Form C-103
Revised July 18, 2013

SUNDRY NOTICES AND REPORTS ON WELLS (DO NOT USE THIS FORM FOR PROPOSALS TO DRILL OR TO DEEPEN OR PLUG BACK TO A DIFFERENT RESERVOIR. USE "APPLICATION FOR PERMIT" (FORM C-101) FOR SUCH PROPOSALS.)		WELL API NO. 30-025-05314
1. Type of Well: Oil Well <input type="checkbox"/> Gas Well <input type="checkbox"/> Other SWD		5. Indicate Type of Lease STATE <input type="checkbox"/> FEE <input checked="" type="checkbox"/>
2. Name of Operator Legacy Reserve Operating, LP		6. State Oil & Gas Lease No. N/A
3. Address of Operator PO Box 10848, Midland TX 79702		7. Lease Name or Unit Agreement Name L R Chamberlin
4. Well Location Unit Letter: K , 2310 feet from the South line and 2310 feet from the West line Section 14 Township 15 S Range 37 E NMPM Lea County		8. Well Number 4
11. Elevation (Show whether DR, RKB, RT, GR, etc.) 3790 GL		9. OGRID Number 240974
		10. Pool name or Wildcat SWD; Dev'n

July 31, 2017

On behalf of Legacy Reserves Operating, LP (OGRID 240974), I am requesting approval of minor modifications of SWD-1678 for Legacy's L R Chamberlin 4 (30-025-05314). The well (in K-14-15s-37e) will dispose into the SWD; Devonian (96101). Proposed changes ar

REVISED PLAN

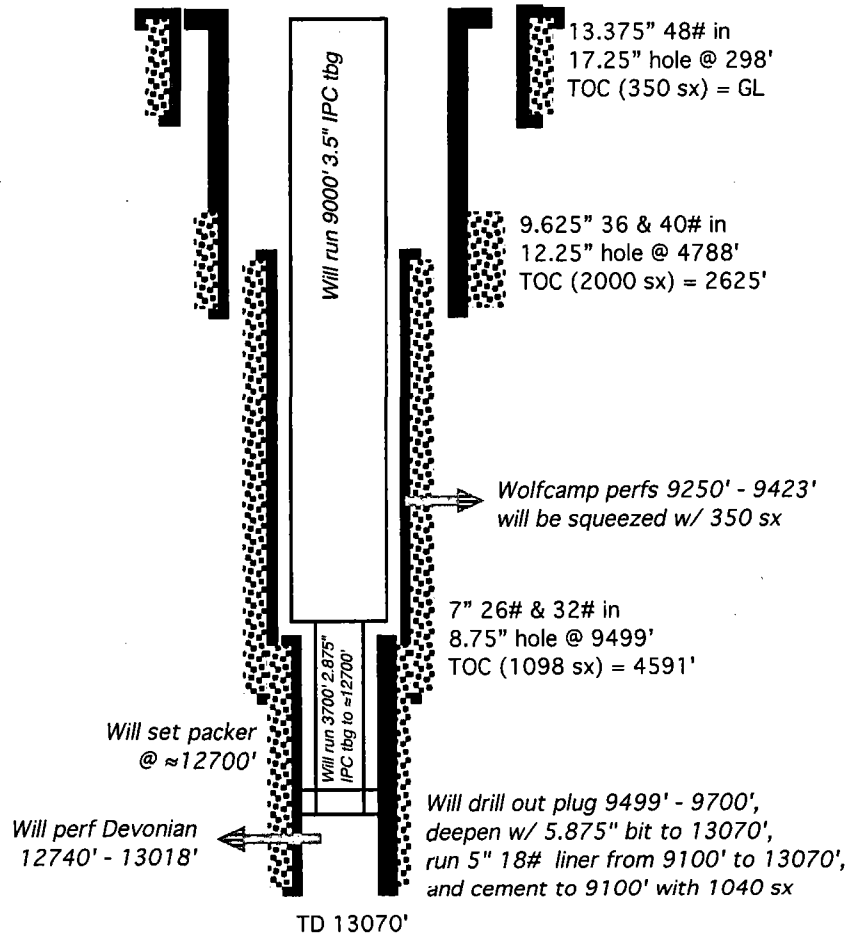
Original Plan	Revised Plan
Liner	5.5# 20# N-80 from GL to 13018'	5" 18# L-80 from 9100' - 13070'
Liner cement	1830 sacks	1040 sacks (1227 cubic feet) Class H Premium + 1% silica fume + 0.2% dispersant + 0.2% sodium metasilicate + 0.55% retarder. Density = 15.6#/gal. Yield = 1.18 cu ft/sack.
Liner TOC	GL	9100' (TOL)
Perforations	12600' - 13018'	12740' - 13018'
Packer	12550'	12700'
Tubing	12550' of 2.875" IPC	9000' of 3.5" IPC + 3700' of 2.875" IPC
TD	13018'	13070' w/ 5.875" bit

Will drill out plugs and deepen with 5.875" bit to 13070'.

Run 5" 20# N-80 liner from 9100' to 13070'.

Cement liner with 1040 sacks (1227 cubic feet) Class H Premium + 1% silica fume + 0.2% dispersant + 0.2% sodium metasilicate + 0.55% retarder. Density = 15.6#/gal. Yield = 1.18 cu ft/sack. TOC = TOL. Will confirm TOC with CBL.

Perforate from 12740' to 13018'.

Set packer @ 12700' and run 9000' of 3.5" IPC + 3700' of 2.875" IPC.
